# Fosse Green Energy

EN010154

## 9.19 Applicant's Response to the Examining Authority's Second Written Questions

20 March 2026

EN010154/EXAM/9.19

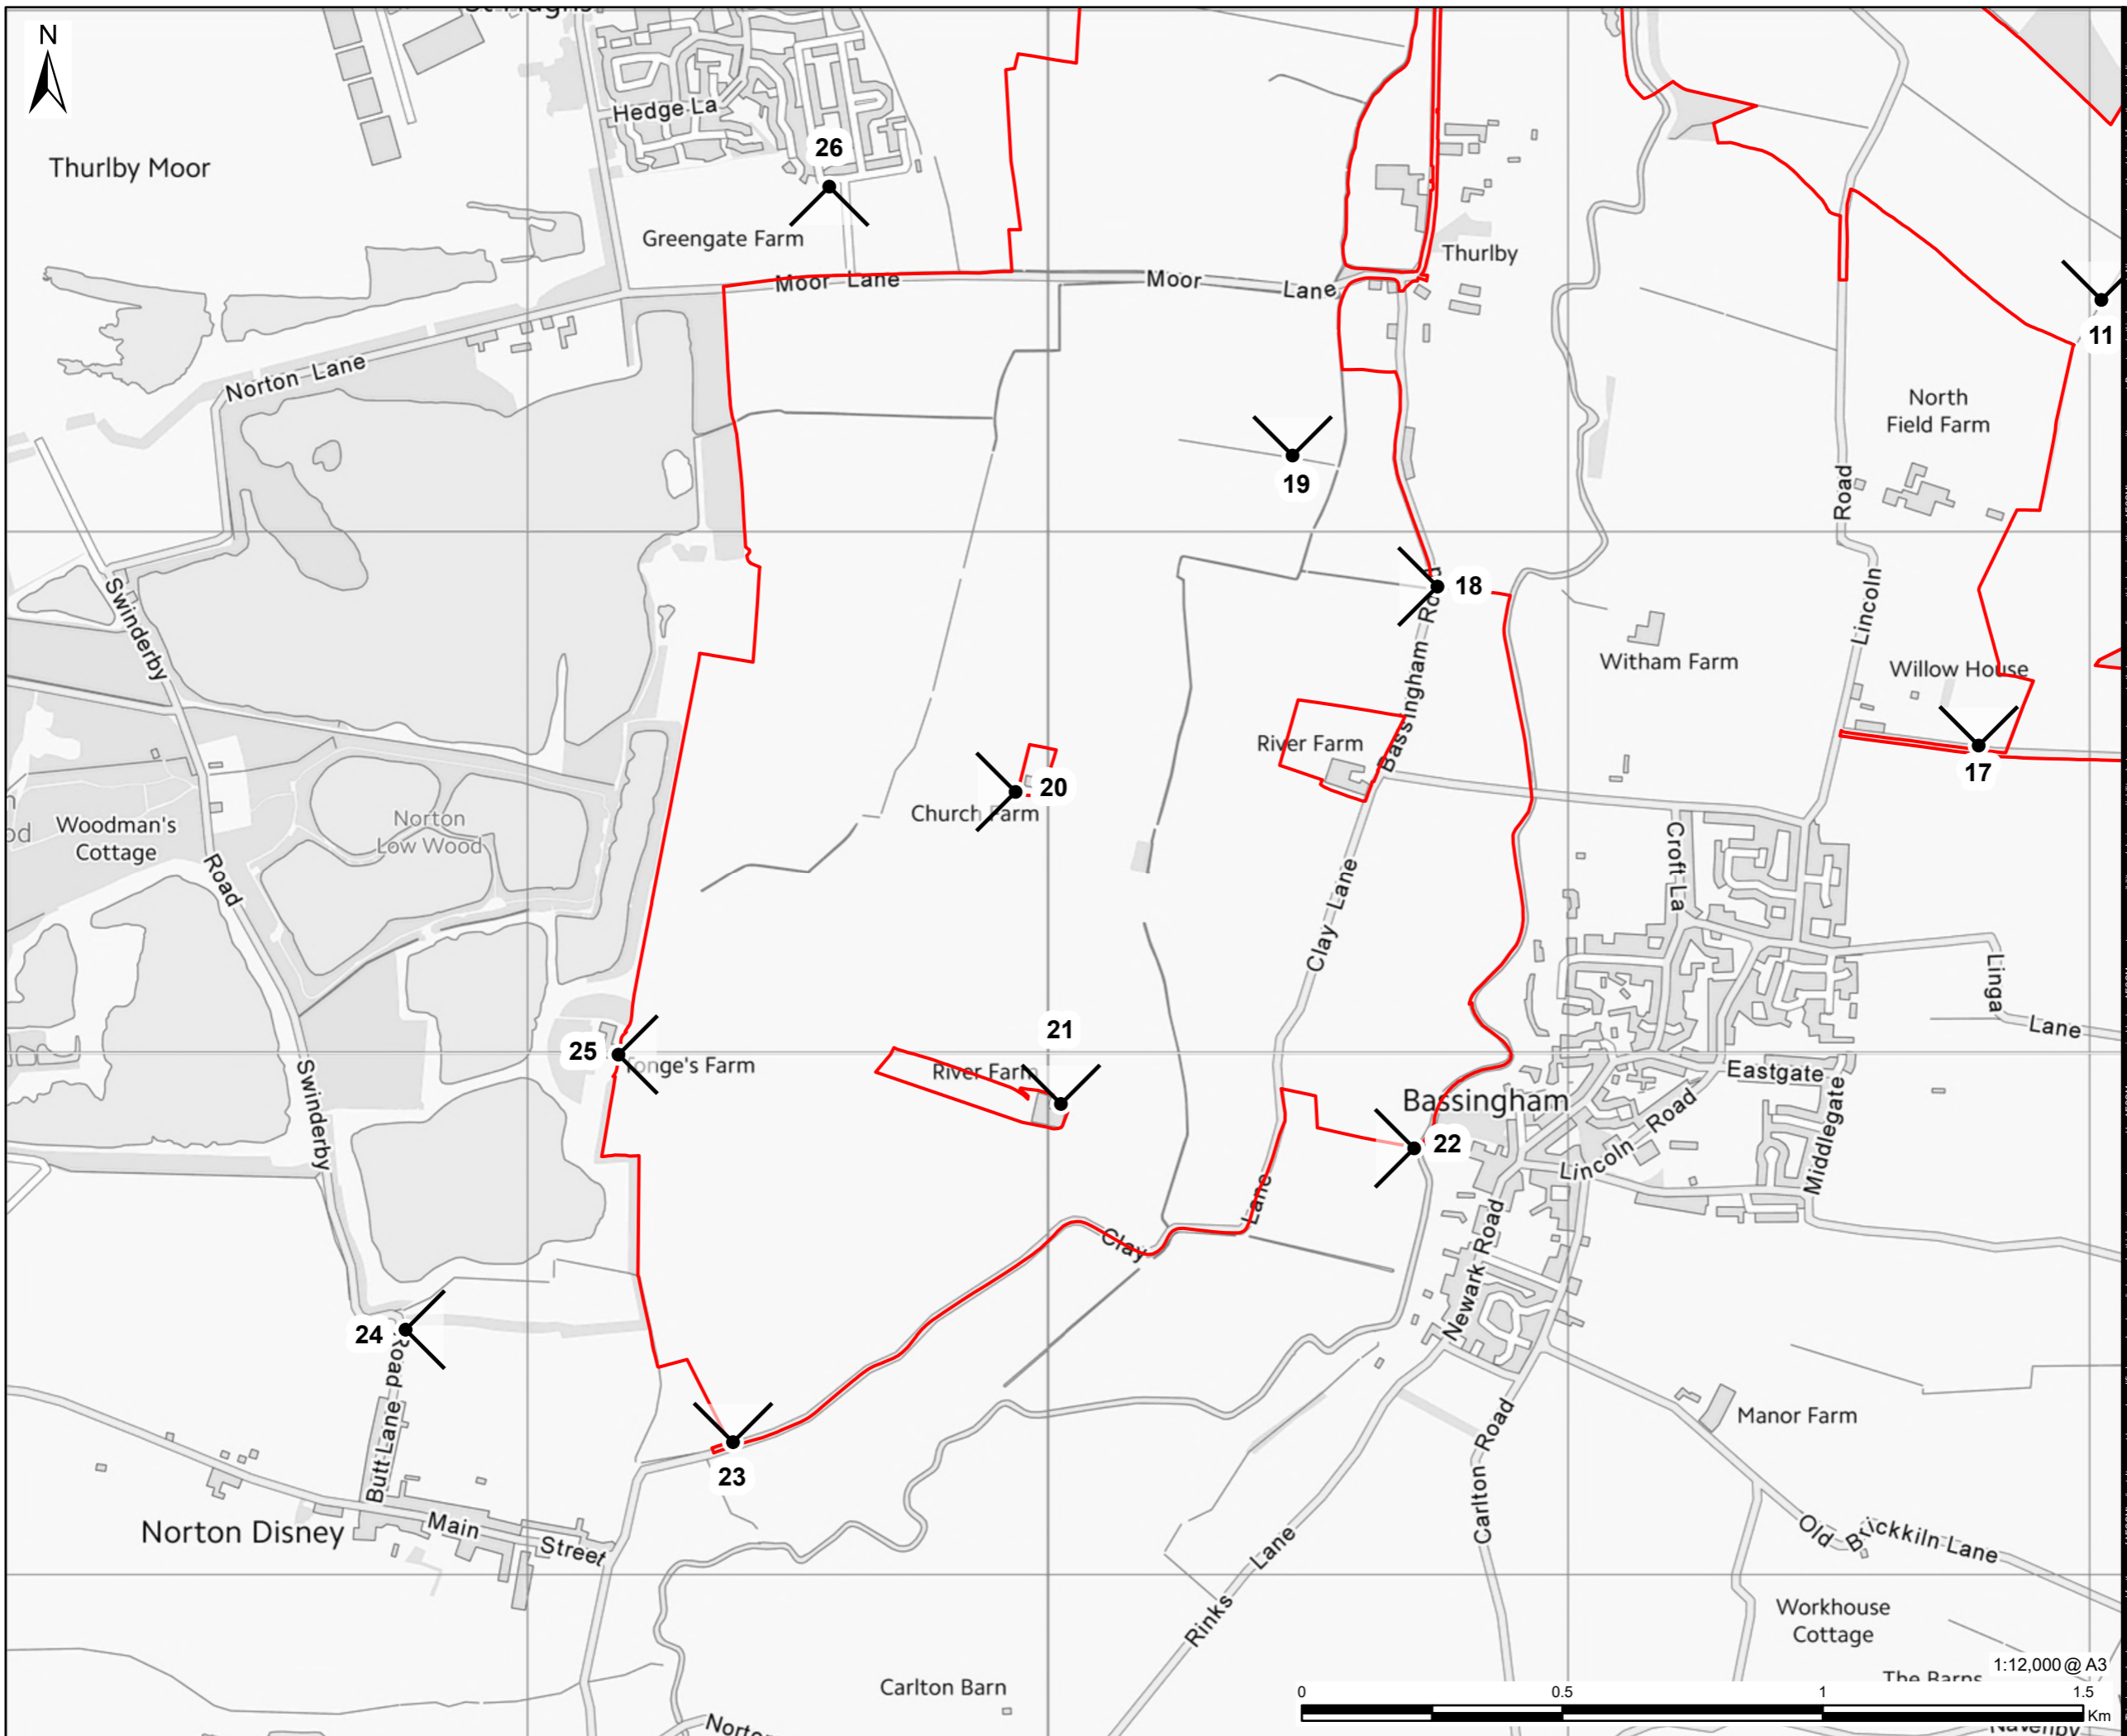
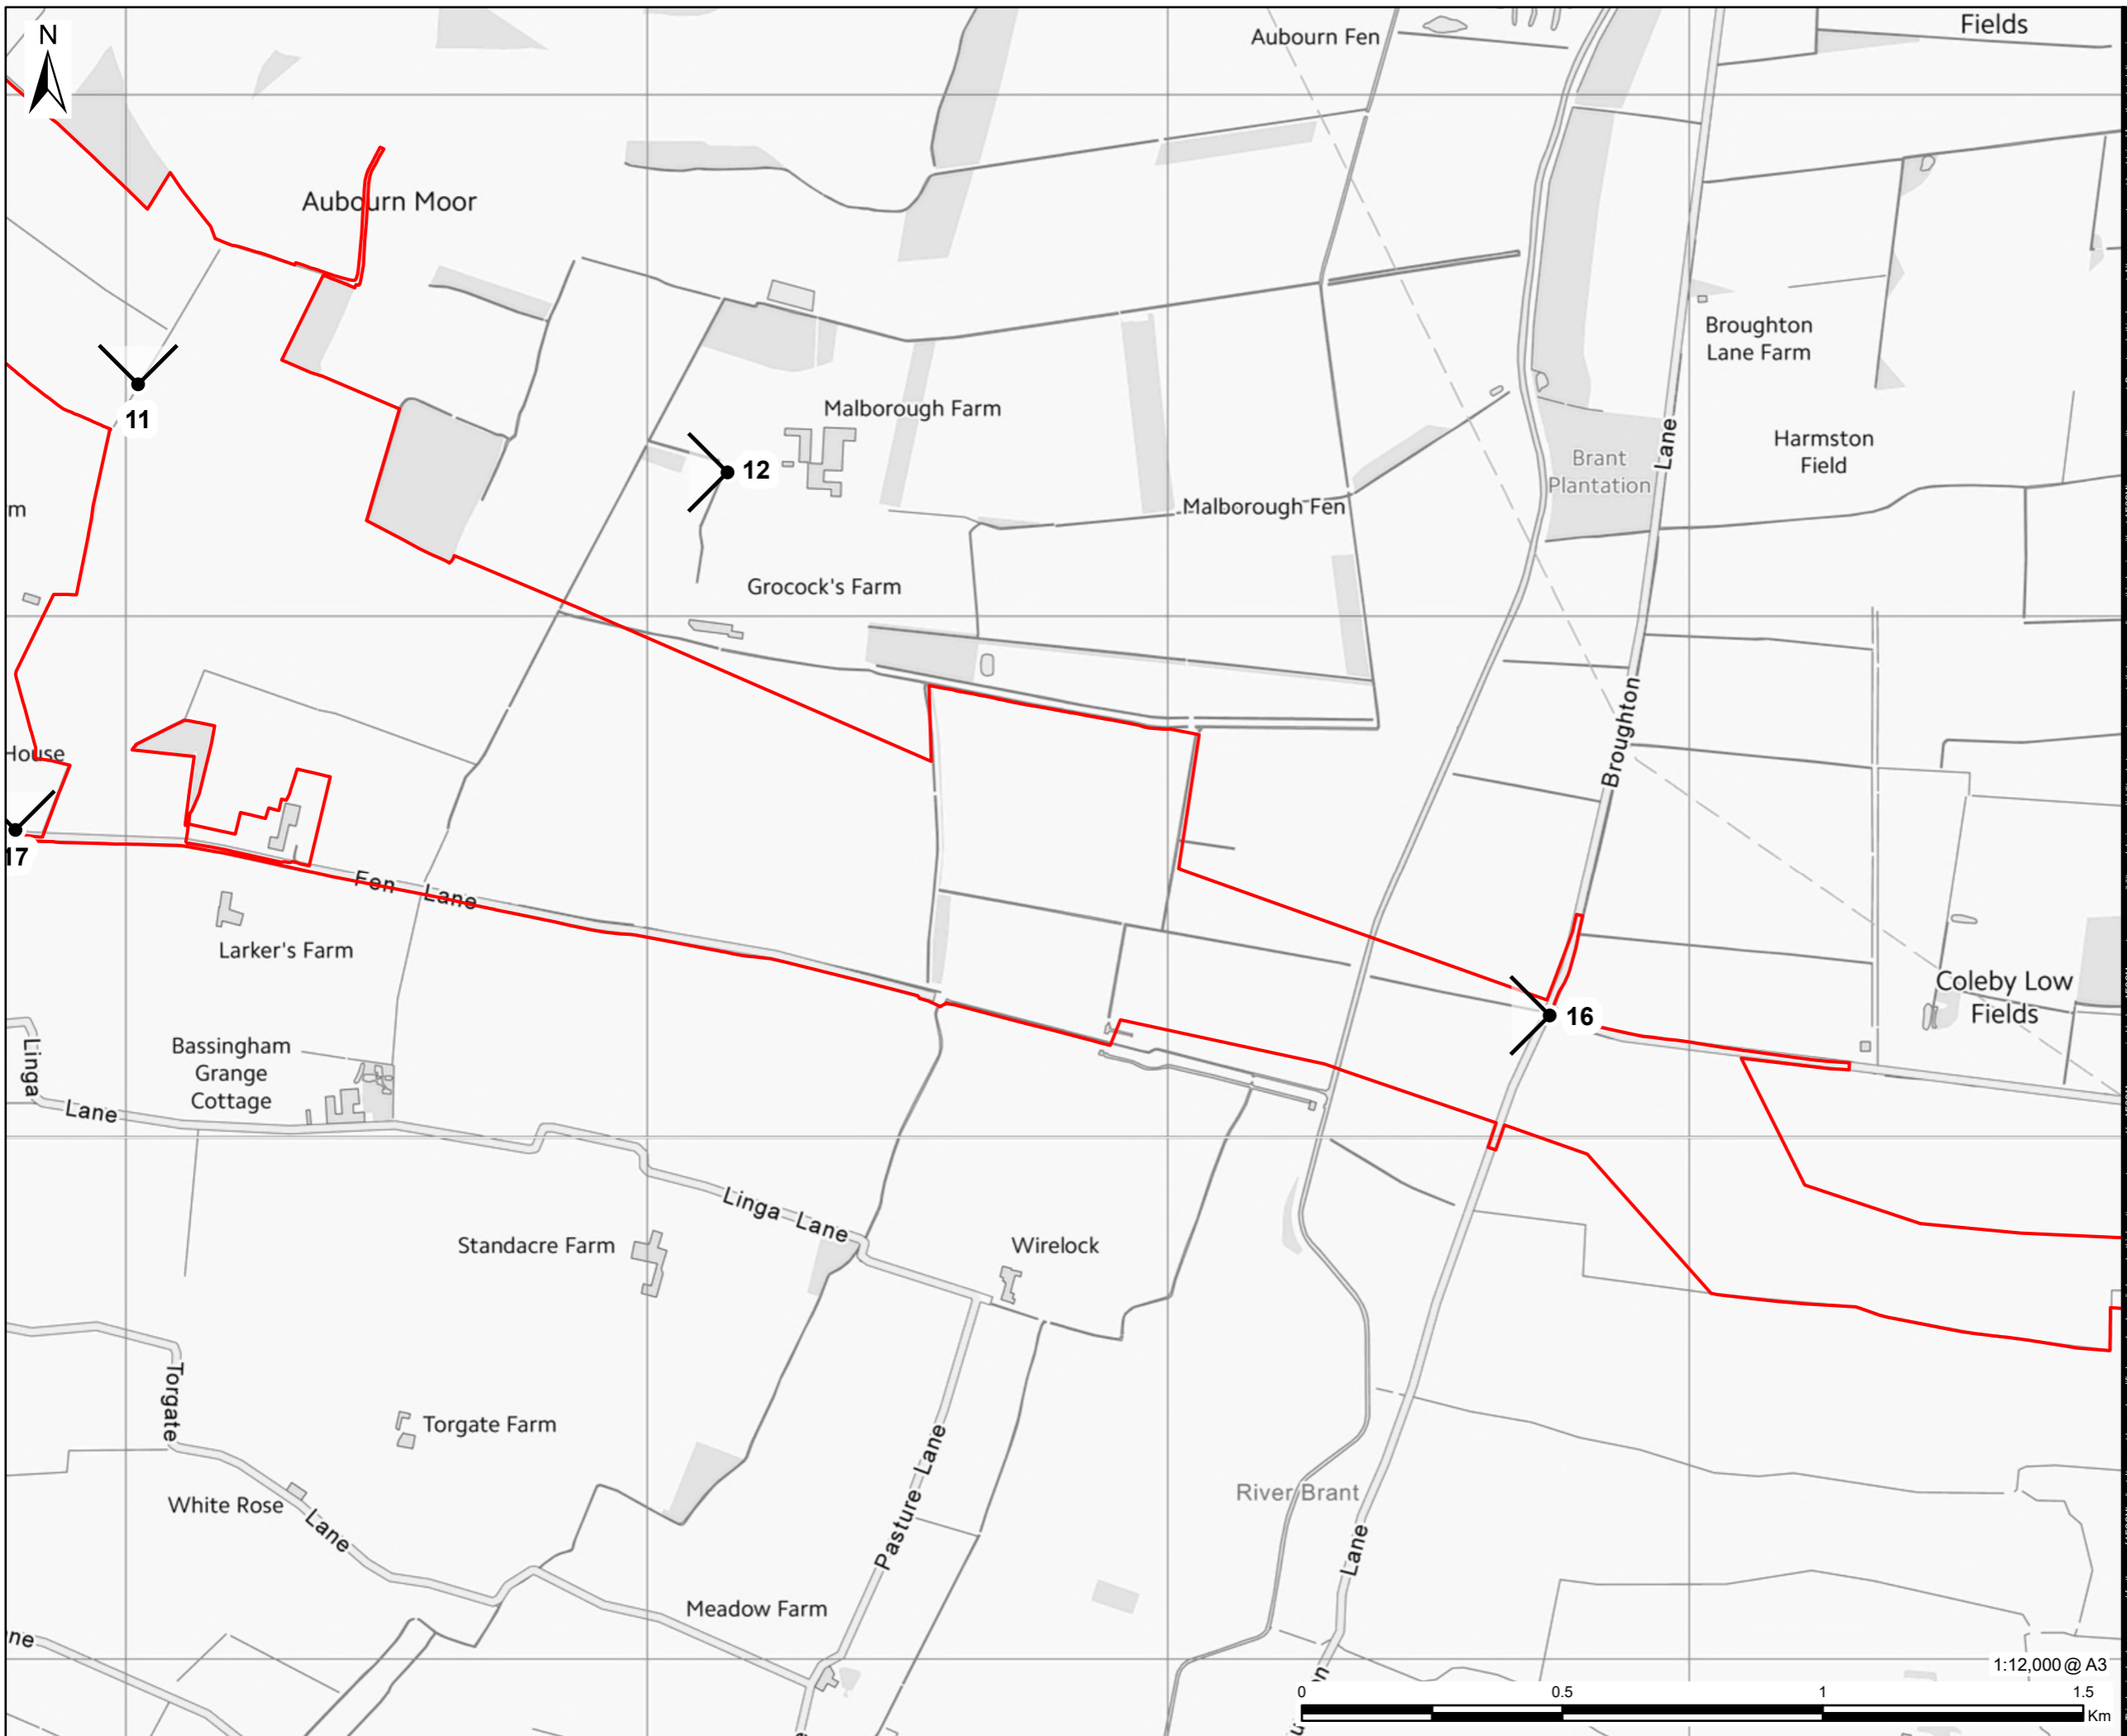
Question Number	Question to:	Question	Applicant Response
<b>Landscape and Visual (LV)</b>			
LV.2.01	Applicant	<p><b>Plans showing the locations for viewpoints and photomontages</b> The ExA notes the applicant's response to ExQ1 LV.1.01 (Plans showing the locations for viewpoints and photomontages), most particularly the reliance placed on ES Figure 10-7 Zone of Theoretical Visibility – Barrier Earth, with Viewpoint Locations (Rev B) [AS-059] as the means for identifying the locations for the viewpoints and photomontages used in the submitted assessment of the proposed development's landscape and visual amenity effects. However, ES Figure 10-7 [AS-059] is affected by limited contextual mapping information relating to road/street and property naming that the ExA referred to in item 1(a) in its procedural decision letter dated 22 August 2025 [PD-005]. That, taken together with the scale of ES Figure 10-7 (1:60,000), makes it difficult to identify the precise locations for some of the viewpoints and photomontages without recourse to other submitted figures.</p> <p>The ExA therefore considers the answer to ExQ1 LV.1.01 to be unsatisfactory. Accordingly, the applicant should submit a plan (or plans) appropriately scaled with adequate contextual information to enable the locations for the viewpoints and photomontage to be clearly identified.</p>	<p>Please see Figure WQ2-1 provided in Appendix A, which illustrates the location of the viewpoints at a 1:12,000 scale with additional contextual location information.</p> <p>Figure 10-8 Viewpoint Photography [APP-095] and Figure 10-10: Photomontages [APP-097] and [AS-119] of the ES also provide locational information (such as location coordinates) beneath each respective image.</p>
